FINAL PLAT
BROCK SECOND ADDITION
AN ADDITION TO WICHITA, SEDGWICK COUNTY, KANSAS

Re: S/D 96-74 - BROCK SECOND ADDITION (Final Plat)

At the regular meeting of the Subdivision Committee of the Metropolitan Area Planning Commission on Thursday, November 7, 1996, the above captioned plat was considered. The action of the Committee was to recommend that this plat be approved subject to:

CASE NUMBER: S/D 96-74 BROCK SECOND ADDITION

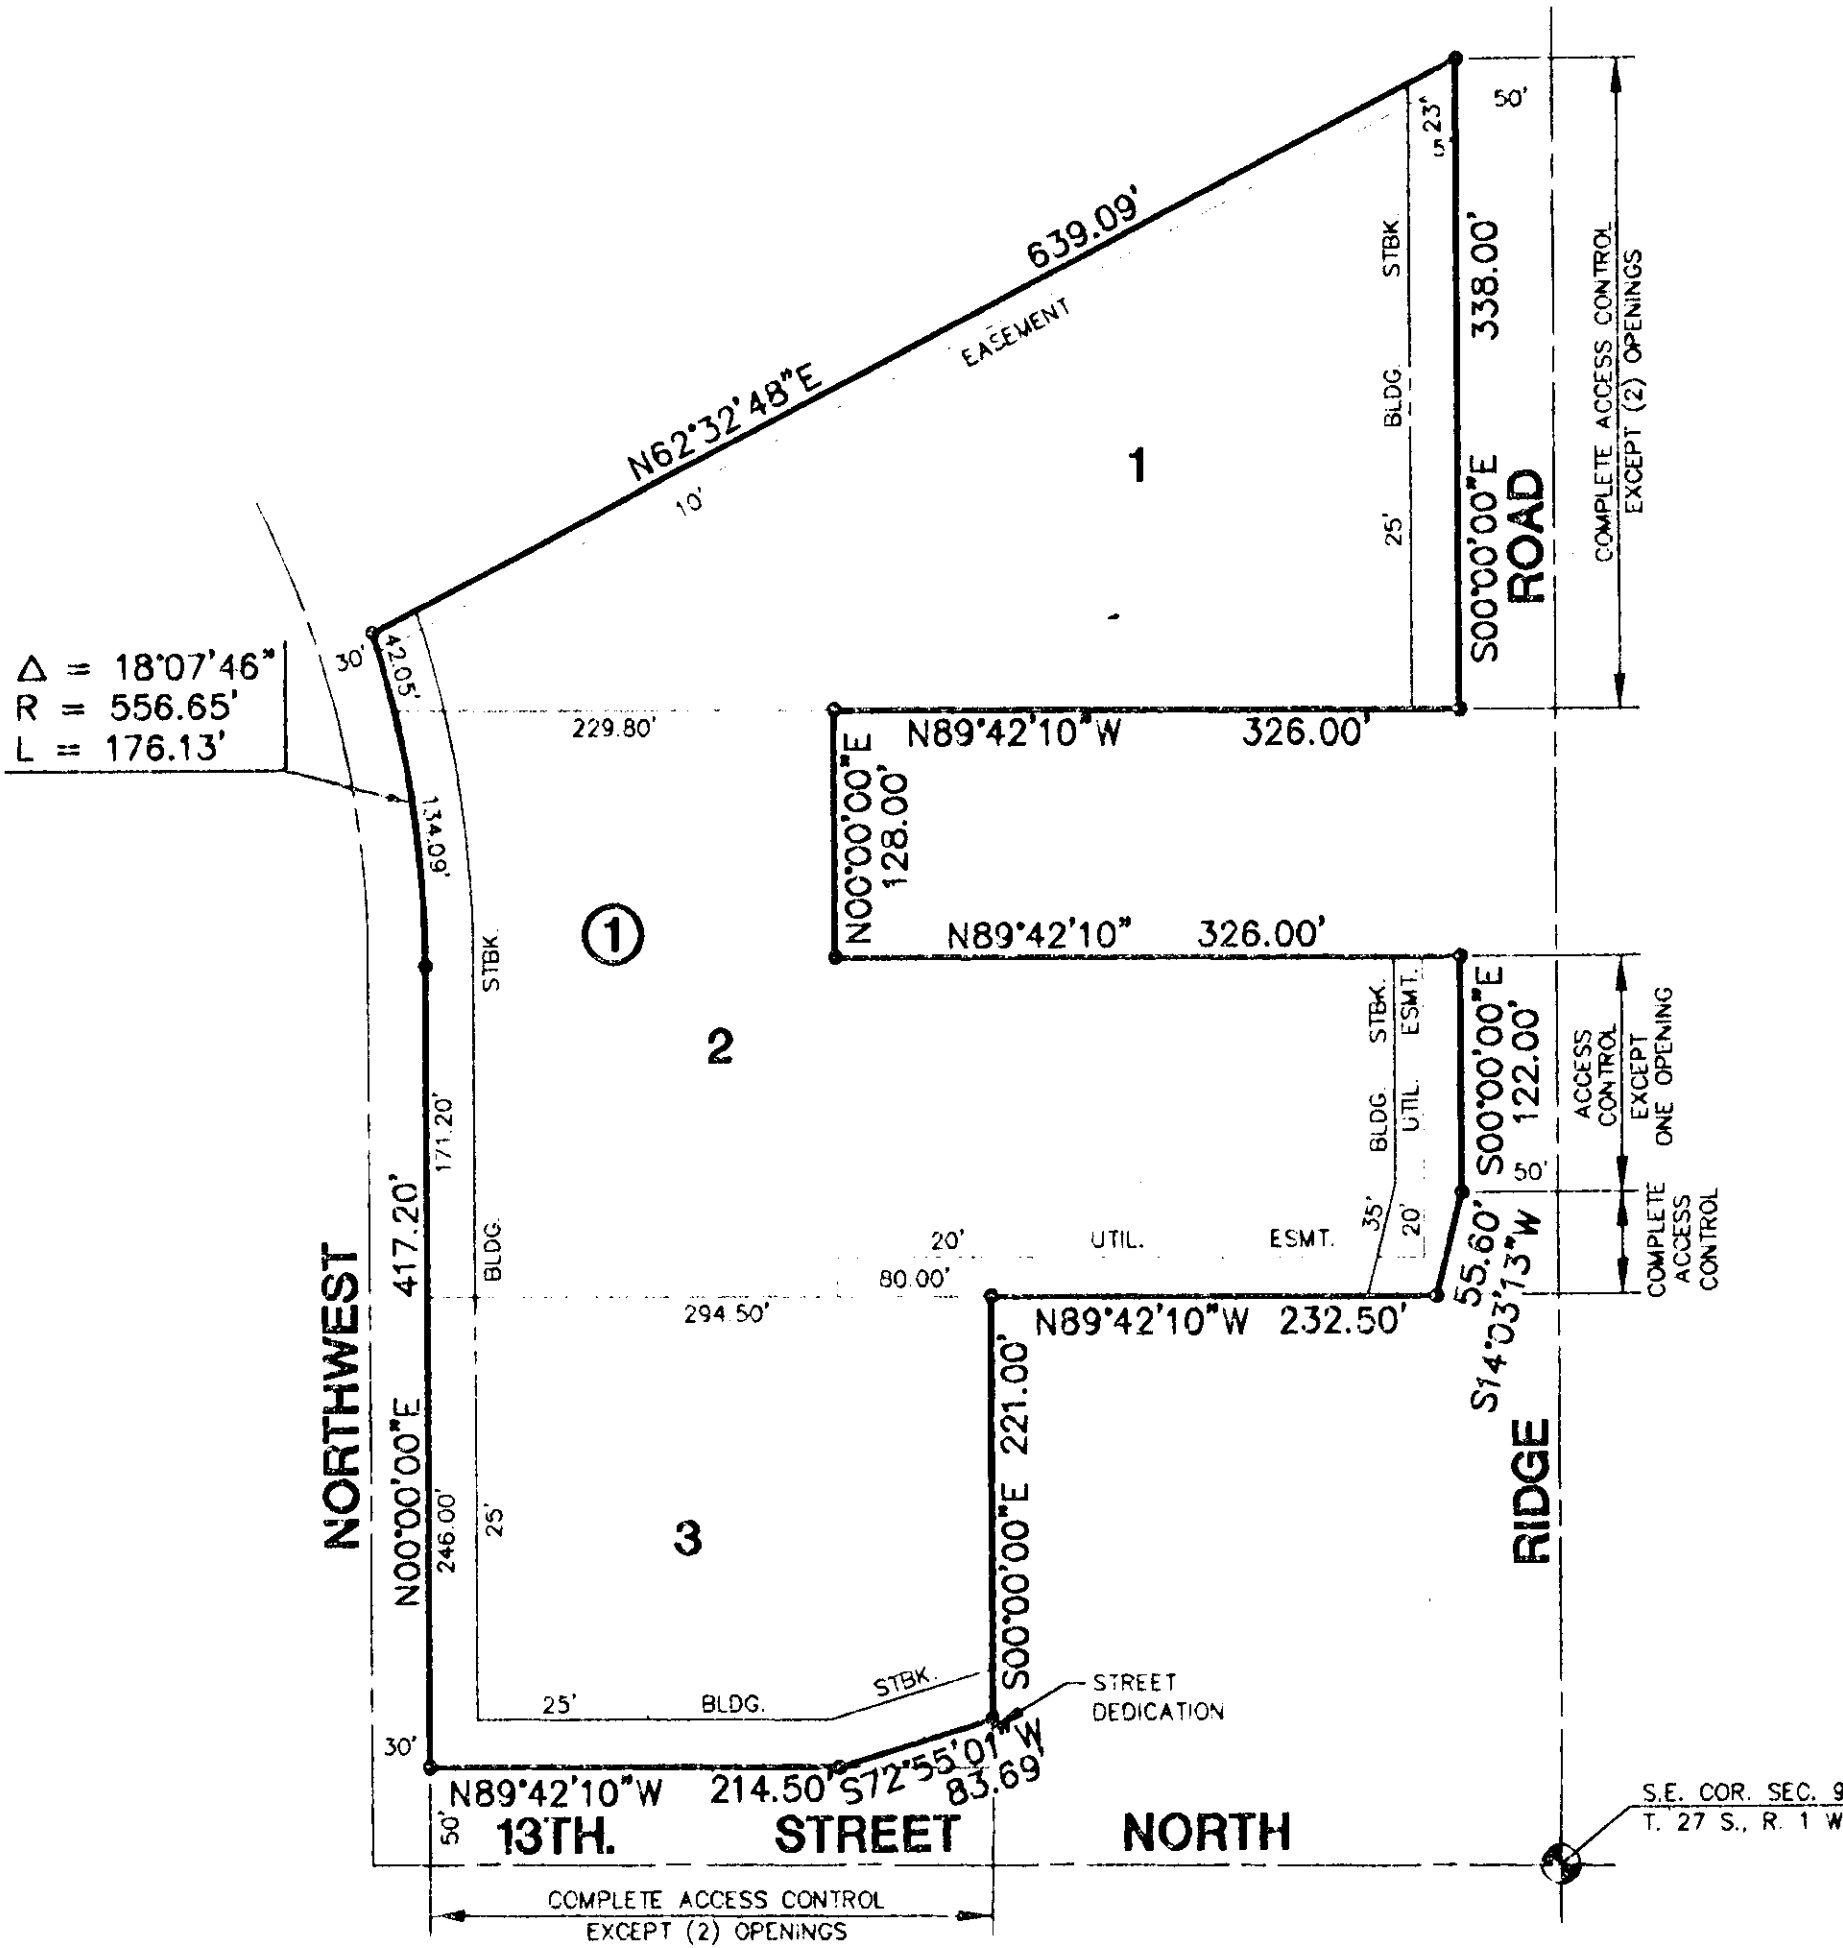
Submit a 3-lot plat as proposed but with the dedication of complete access control to Northwest Parkway from the adjacent lots. Cross-lot access agreements for Lot 2 to use access through adjacent Lots 1 and 3 to Ridge Road and 13th Street North shall also be provided. For Lot 2, as required by the City's Fire Department, an emergency access easement shall be shown to Northwest Parkway and any related improvements shall be agreed to (curbing, gates, etc.). Any such easements shall be clearly indicated in the plat and shall be unencumbered by parking spaces or any other possible obstructions.

However, if the applicant is unable to secure cross-lot access agreements for Lot 2, from the adjoining property owners involved in this plat, a one-lot plat may be submitted for City Council approval. One "temporary" opening shall be allowed to Northwest Parkway in such case. The plat's text shall note in this case, that complete access control is contingently dedicated such that upon the future platting of these adjoining parcels, if cross-lot access is obtained at the time of such properties platting, that access to Northwest Parkway will be discontinued and that the existing opening will be converted to an emergency access opening only.

- C. Since an opening or openings is to be provided for Lots 1 and 3 to the adjacent streets, the word "complete" shall be deleted from those areas where access is being provided.

- D. On the final plat tracing additional information shall be shown in regard to this plat's tie point. Specifically, a dimension should be indicated from the Southeast corner of Section 9 to one of the plat's corners and/or a tie point also indicated to an existing lot.

- E. On the final plat tracing, an appropriate title should be indicated for Mark Stanford of Cooperstown, Inc. on the platlor's signature line.
- F. On the final plat, the MAPC Chairman shall be indicated as John C. Frye.

- H. The applicant's engineer is advised that the Register of Deeds is requiring the name(s) of the notary public, who acknowledges the signatures on this plat, to be printed beneath the notary's signature.

- I. Perimeter closure computations shall be submitted with the final plat tracing. Section 5-101(c).
- J. Recording of the plat within 30 days after approval by the City Council and/or County Commission.
